Re: Product change notification for Harwin product.

There has been a change to the M300 range, affecting a visual feature on all male connector housings. The following ranges are affected:

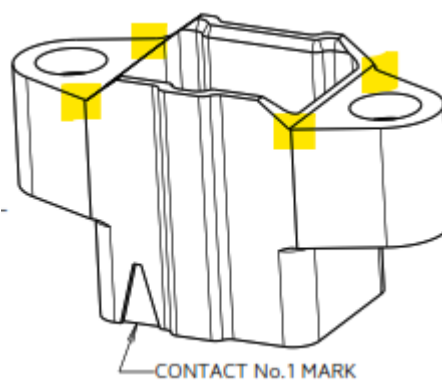
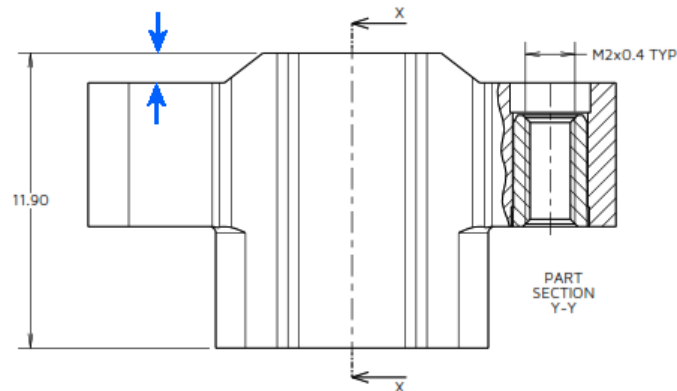
We have made a visual edit to some features around the corners of the mating face. These cut-out features were on both sides of the connector, on all 4 corners - they have been removed:

The distance from the edge of the shroud to the mating face of the fixings has also been reduced from 1.4mm to 1.2mm nominal (indicated with blue arrows below). The overall dimensions and the mating heights of the connectors are not affected.
